**STATE OF RHODE ISLAND AND PROVIDENCE PLANTATIONS  
PUBLIC UTILITIES COMMISSION**

THE NARRAGANSETT ELECTRIC	:	
COMPANY d/b/a NATIONAL GRID'S	:	
NEED TO CONSTRUCT AND ALTER	:	PUC Docket No. 4614
CERTAIN TRANSMISSION COMPONENTS	:	
IN THE TOWNS OF PORTSMOUTH AND	:	
MIDDLETOWN (AQUIDNECK ISLAND	:	
RELIABILITY PROJECT)	:

**NATIONAL GRID'S RESPONSE TO THE  
RHODE ISLAND DIVISION OF PUBLIC UTILITIES'  
INTERROGATORIES AND REQUESTS FOR PRODUCTION – SET II**

**ULTIMATE ARRANGEMENT**

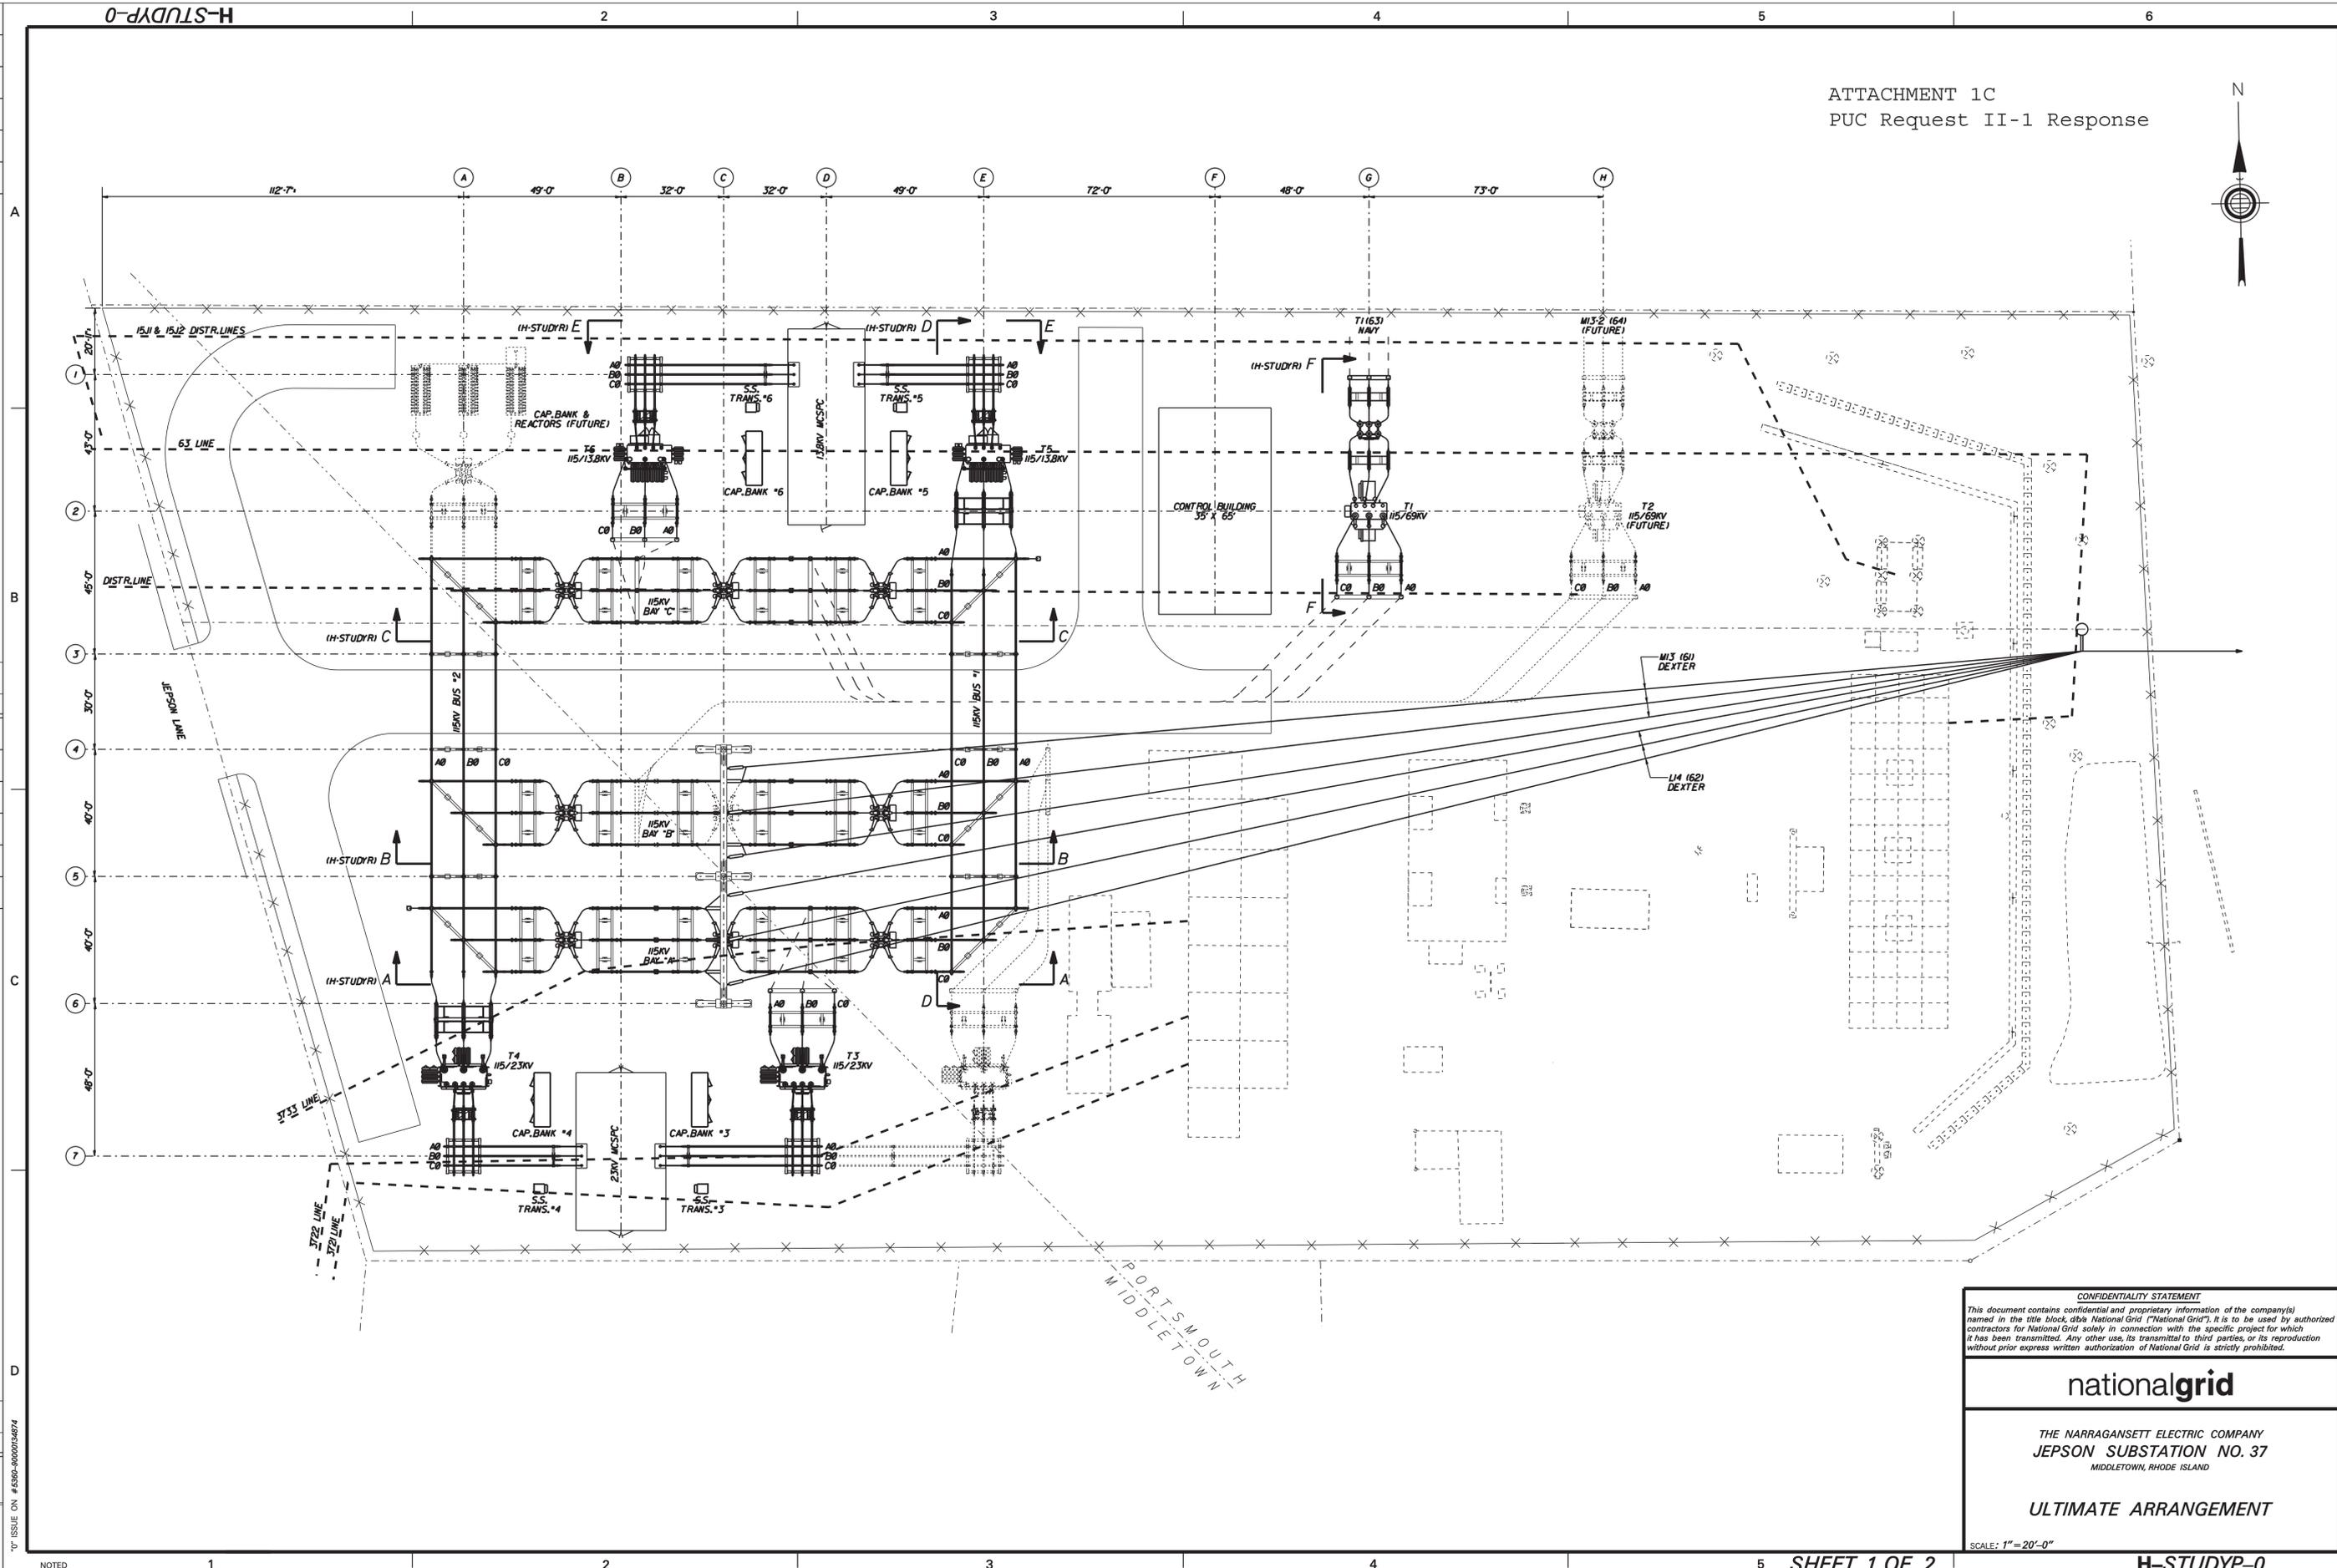
**REQUEST NO. R-II-1:** Regarding the reuse of the exiting Jepson Substation site (see Witness Fiku testimony, page 5), please provide all study material and support documents developed to determine that the existing site would be rejected, including substation layout, cost estimates, parcel maps indicating boundaries of currently owned property and adjacent property for sale, and topography maps.

**RESPONSE NO. 1:** Attached is the property plan of the existing substation site titled “PLAN OF LAND FOR JEPSON SUBSTATION SITUATED ON JEPSON LANE MIDDLETOWN & PORTSMOUTH RHODE ISLAND PREPARED FOR NATIONAL GRID” drawn by Garofalo & Associates, Inc. dated December 8, 2009 (Attachment 1A) and two substation layouts titled “THE NARRAGANSETT ELECTRIC COMPANY JEPSON SUBSTATION NO. 37 MIDDLETOWN, RHODE ISLAND ULTIMATE ARRANGEMENT H-*STUDYN-0*” (“H-*STUDYN-0*”) (Attachment 1B) and “THE NARRAGANSETT ELECTRIC COMPANY JEPSON SUBSTATION NO. 37 MIDDLETOWN, RHODE ISLAND ULTIMATE ARRANGEMENT H-*STUDYP-0*” (“H-*STUDYP-0*”) (Attachment 1C) developed to evaluate this site for the new substation. The first layout, H-*STUDYN-0*, was a conventional all overhead conductor substation. This option was rejected for the reasons listed in Section 5.4.1 of the Environmental Report (“ER”). These reasons include space restrictions, complexity of construction sequencing and outage scheduling working close to an energized station as well as multiple temporary line relocations that would be required. In an effort to address some of these

issues, a second layout, H-STUDYP-0, was developed using some underground cable connections. This option did not ease the space restrictions or constructability issues.

As part of its alternative analysis, the Company reviewed re-use of the existing site. Two plans were evaluated (Attachments 1B and 1C). The first option (Attachment 1B) was a conventional, all overhead conductor substation. This option was rejected for the reasons listed in Section 5.4.1 of the Environmental Report. These reasons include space restrictions, complexity of construction sequencing and outage scheduling, and working close to an energized station. In addition, multiple temporary line relocations would be required for this option. In an effort to address some of these issues, a second layout (Attachment 1C) was developed using some underground 115 kV and 13 kV cable connections within the substation and undergrounding a section of the 69 kV transmission line (63 Line) continuing to Newport. This option minimized the extent of conflict with existing substation facilities, but did not overcome other shortcomings of the first option. This option increases the project cost due to the need to underground 115kV circuits and the time to repair in the event of cable faults.

The property contains approximately 4.1 acres and is approximately 310 feet wide and 640 feet deep. The existing substation is set back from the road, however the area closest to the road is not completely open space. It serves as a corridor for two overhead 4 kV feeders, three overhead 13 kV feeders, and three overhead 23 kV sub-transmission lines, in addition to the 69 kV transmission line (63 Line) to the Navy substation. These lines would need to be relocated from this area to allow substation construction. Since there is no usable abutting property to the north or south, these lines would need to stay on the substation property. In addition even if the new, all overhead, substation layout was located as close to Jepson Lane as possible, it would still conflict with the existing 23 kV control house and bus structure. There was no feasible construction sequence to work around the 4kV, 13 kV and 23 kV feeders as well as the 23 kV control house and bus structure interference.

Using the second layout with underground ties and feeders would avoid a direct conflict with the existing 23 kV bus structure. Although the control house would be very close to the new work, a potential, high level construction sequence was evaluated:

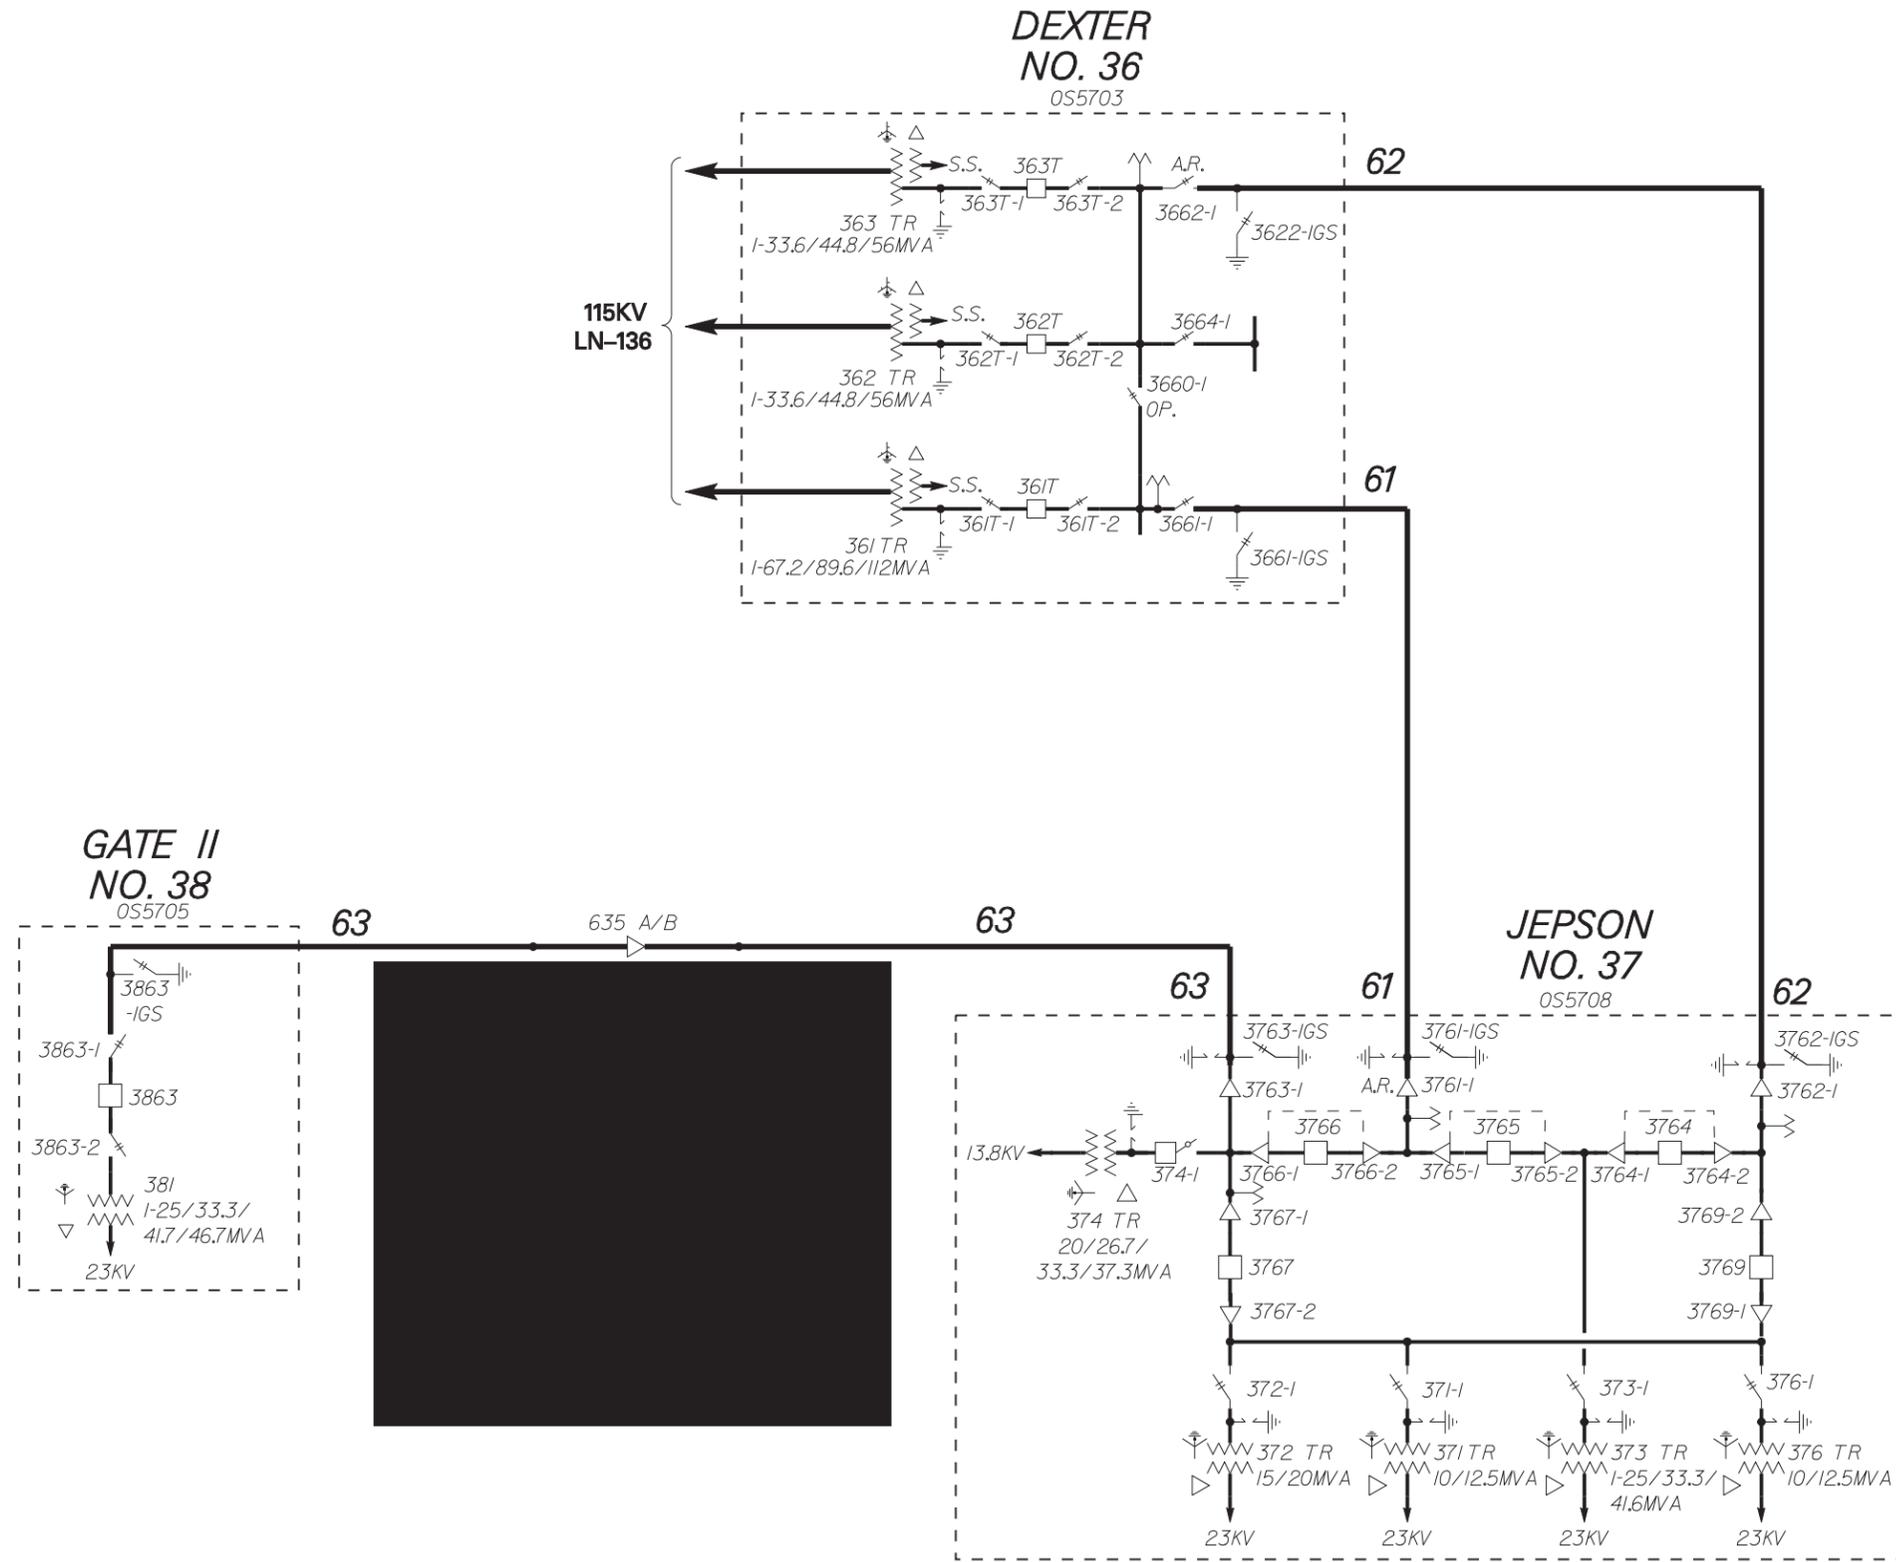
**REQUEST NO. R-II-3:** Provide a transmission one-line for the current and proposed configuration showing Line #61, #62 and #63. Include all related substation

**RESPONSE NO. 3:** The current configuration one-line showing Line #61, 62, and 63 and related substations is shown on the attached “LN-603 69KV Lines 61, 62 & 63” (redacted) (Attachment 3A). For the Proposed configuration see *Figure 5-4 extracted from Aquidneck Island – Solution Study Report – April 2015.pdf* (See Attachment 2A).
